Subject: Electric Power Research Institute comments on the draft ACNW report:
“Igneous Activity at Yucca Mountain: Technical Basis for Decision Making”

Attachment A:
**Comments from the Electric Power Research Institute on the ACNW draft report
on “ Igneous Activity at Yucca Mountain: Technical Basis for Decision Making”**

Attachment B:
**EPRI's preliminary response to NRC's "Review of Two Electric Power Research
Institute Technical Reports on the Potential Igneous Processes Relevant to the
Yucca Mountain Repository"**

Fig. 1: Conceptual model of flow regime in magma filled dike prior to intersection with a drift (not to scale). White areas denote gas phase and grey denotes liquid magma.

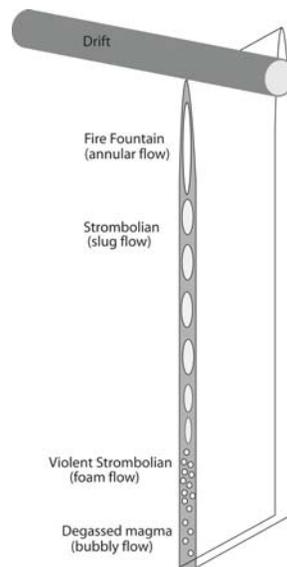
In Section 2 (Nature of Magma in the Drift), the reviewers believe EPRI asserts that the magma at the tip of the ascending column just prior to and at the point of intersection with the repository will be degassed. Furthermore, the reviewers believe EPRI asserts that magma rising from depth (\gg repository depth) will have a viscosity of 10^5 Pa-s. The reviewers demonstrate (Section 2.1) using solubility equilibrium relations of water in magma as a function of depth that magma at repository depths will have < 1 wt% H_2O thus is in direct contradiction with their assumed definition of EPRI's degassed magma. The reviewers go on to demonstrate (Section 2.2) how exsolved volatiles form bubbles and how those bubbles will be prohibited from rising through an ascending magma that has a viscosity of 10^5 Pa-s thus prohibiting the magma from degassing. The reviewers continue this argument in Section 2.3 with a statement that EPRI's "intruding magma will likely be a volatile-depleted, viscous magma with a low bubble fraction and a rheology characteristic of an *aa* lava flow is largely unsupported by the condition govern exsolution". The last paragraph of this section asserts that EPRI believes magma initially entering the repository that was just intersected by the dike tip will be quiescent. The reviewers go on to state that analogs of monogenetic cinder cones start off with an intense jetting-style of explosive discharge and that effusive discharge of lava flows erupt continuously throughout these eruptions.

EPRI's 2006 model (see attachment) suggests that a dike in the Yucca Mountain region is expected to be non-uniform both laterally and vertically with respect to rheology. Magma with the lowest viscosity is expected in the active or the widest part the dike (Fig. 1) and more crystalline viscous magma is expected along the outer regions or the thinner

parts of the dike. The lateral variation in magma properties will produce in general two different styles of expected activity upon entering a drift. Magma may either be a mixture of gas and fragmented clots of magma characteristic of a lava fountain phase (non-crystallizing liquid in which volatiles are being released) or a mixture of crystals and liquid characteristic of *aa* lava (crystallizing magma relatively depleted in volatiles). We refer the reader to the attached paper (Attachment C) entitled “Conceptual Model For Defining Natural Analogs for Future Yucca Mountain Volcanism And Expected Consequences” for more detailed description of EPRI’s current model utilizing recently published data from DOE (i.e. Valentine et al., 2005). EPRI will be reviewing additional papers recently published by DOE in 2006 and 2007 as we continue to develop our conceptual model based on field observations made in the Yucca Mountain region.

Figure 2 (Fig. 4-1, EPRI, 2002): Computational configuration of the Woods et al. (2002) model (taken from Figure 3 in Bokhove and Woods, 2002).

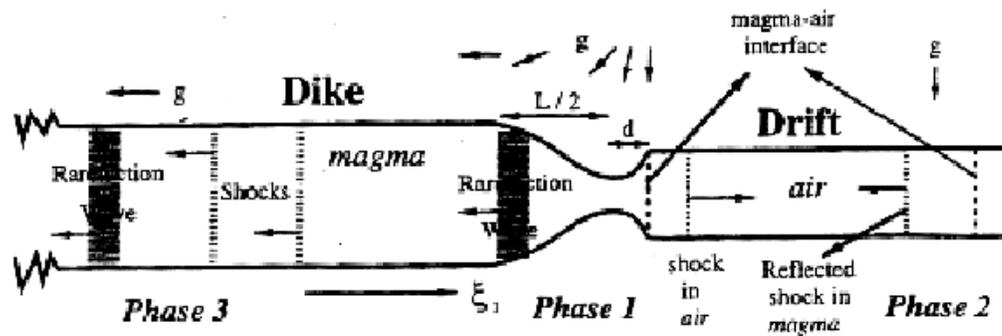
In Section 4 (Magma Dynamics), the reviewers state that the thermal and heat transfer analysis in EPRI's flow analysis does not appear to be consistent with fundamental physical and chemical processes at volcanic eruptions. The main criticism is that EPRI does not provide sufficient information to assess the numerics of the simulation such as numerical scheme, spatial and temporal discretization and details of the computational grid. The reviewers comment that the geometric condition of the dike and the drift cannot be adequately modeled as a nozzle flow problem and there is no rationale provided to explain the significance of the divergent feature in the dike geometry.

EPRI clearly states that the simulations were set up using the geometry of for calculations published in Woods and others (2002) and Bokhove and Woods (2002). As shown in Fig. 2, the one-dimensional model is the configuration used by the reviewer. EPRI used the same dimensions and geometric shapes for both the dike and drift from the Woods and others (2002) model. As shown in Fig. 3, the only difference is that EPRI moved the dike to a vertical orientation that EPRI deemed more reasonable (EPRI, 2004). EPRI did use a steam rich fluid however the physics are essentially the same. The main difference (assuming the Woods and others (2002) model included it) is the heat transfer between fragmented magma that would create more vapor phase than the initial conditions, the fluid is more compressible than an ash-gas mixture which would reduce the propagation speed of pressure waves moving through the subsonic flow regions and magma mixture-air interface (Morrissey and Chouet, 1997). The main effect of a single phase is the magnitude of parameters; the physics remains essentially the same. EPRI believes that the result from using the 2-dimensional – vertical dike- configuration is more important to understanding the physics of magma-drift interaction. As stated in EPRI (2004, p.4-20), “Results from the 2-dimensional re-analysis of the Woods et al. (2002) model demonstrate that at high-pressure gradients between the dike and drift, the original dike would be expected to propagate to the surface. This is because the significance of the vertical flow is that it creates a high-pressure (stress) region at the top of drift immediately above where the dike intersects the drift. These localized stresses far exceed what is necessary to open or create a fracture in the roof of the drift that will enable the dike to continue propagating upward. This favors the original dike as the main pathway for magma to reach the surface.”
